**Discussion of ‘Wang, A.D., Wang, W.D., Huang, M.S. & Wu, J.B. (2016) “Interaction factor for large pile groups” *Geotechnique Letters*, vol. 6, pp. 1-8, <http://dx.doi.org/10.1680/jgele.15.00139>’**

**By Brian B. Sheil<sup>a\*</sup> and Bryan A. McCabe<sup>b</sup>**

**Fig. 1** Illustration of FE mesh for  $7^2$  pile group; 68,400 15-noded elements

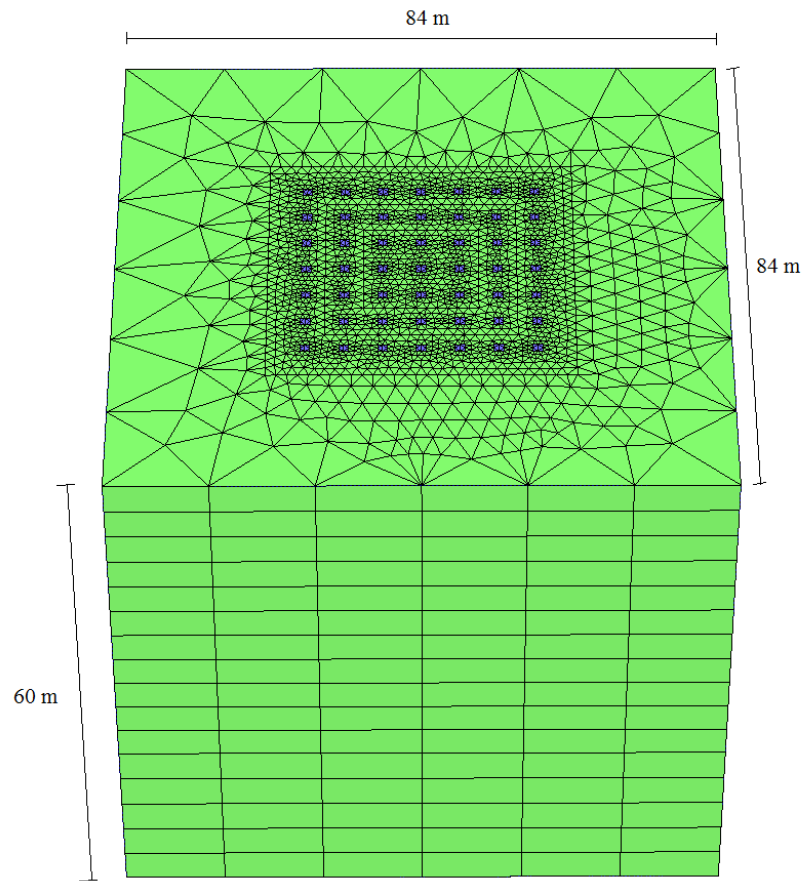
In order to examine the influence of group reinforcing effects on  $\alpha$  directly, a limited number of simulations have been undertaken by the discussers using the FE software package PLAXIS 3D Foundation in conjunction with a LE soil model. An example FE mesh is shown in Fig. 2 for a group of 49 ( $7^2$ ) piles; the particulars of the finite element modelling are available elsewhere (McCabe and Sheil, 2015, Sheil and McCabe, 2014). The discussers have adopted the same geometries employed by the authors and Ottaviani (1975), except that the group piles considered here are free-headed. The values of  $\alpha$  have been calculated using two different sets of analyses: (i) the traditional  $\alpha$  approach using only two piles (Fig. 2a); (ii) the consideration of two piles within a larger pile group (Fig. 2b). From the results presented in Fig. 3a, it can be seen that the presence of the additional non-loaded group piles has a very minor influence on the value of  $\alpha$ , and significantly less than that reported by the authors for their corner pile. Moreover, it can be seen that the influence on the settlement of the loaded pile is also minimal with a reduction of less than 1.5% (Fig. 3b).

**Fig. 3** Influence of free-headed group piles on (a) two-pile interaction factor and (b) the settlement of the loaded 'source' pile;  $L = 40$  m,  $E_s = 24.5$  MPa,  $E_p = 19600$  MPa,  $s = 4$  m,  $a = 1$  m,  $\nu_p = 0.25$ ,  $\nu_s = 0.45$

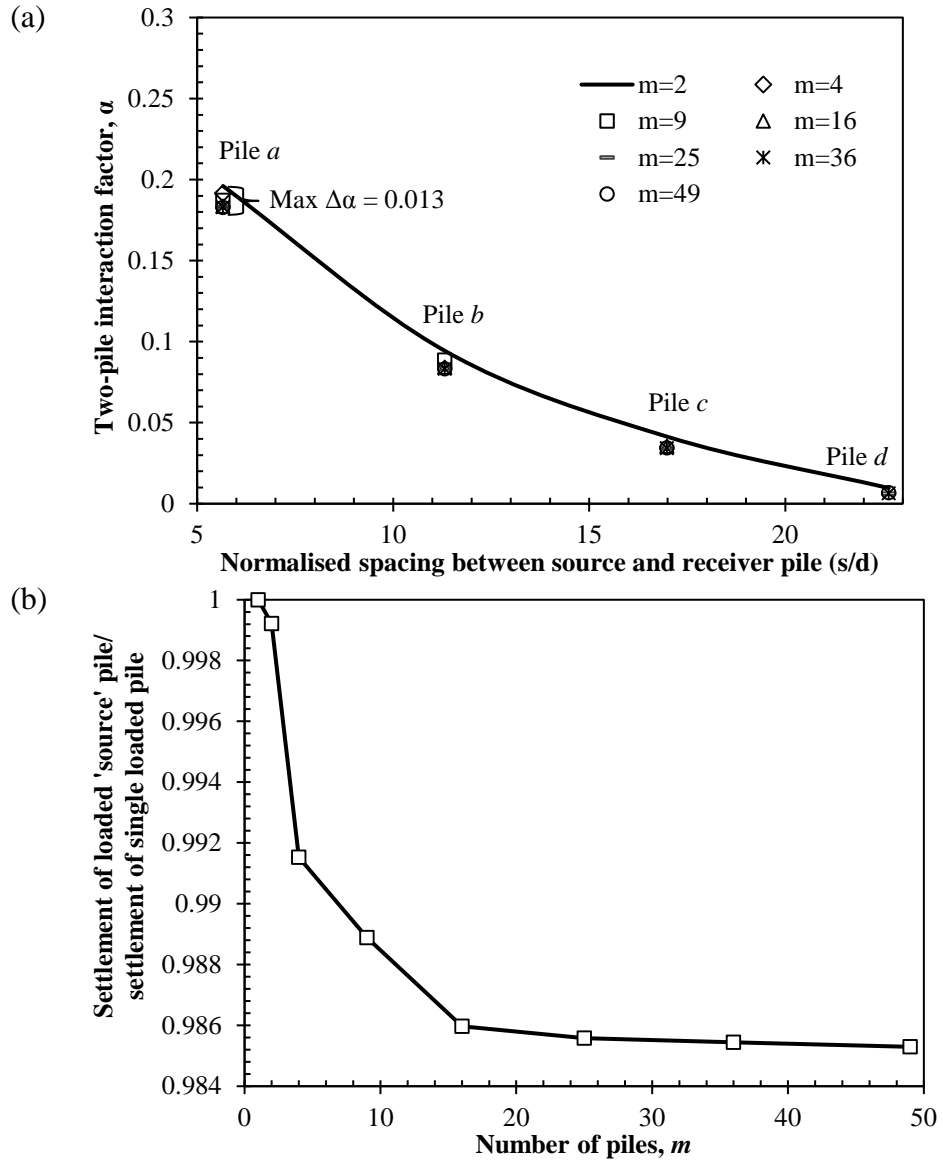
These results appear to contradict the authors' conclusion that group reinforcing effects play an appreciable role for floating pile groups. A comparison between the authors' interaction factors and two-pile interaction factors determined using their FE analysis may go some way to explaining the source of the incongruity. The authors are also invited to revisit their choice of lateral extent for their FE analyses; for a loaded (free-headed) 49-pile group, the discussers observed ~15% difference in the centre pile settlement when the distance to the lateral boundary was increased from 13 m (that used by the authors) to 30 m (used in deriving the data for Fig. 3).
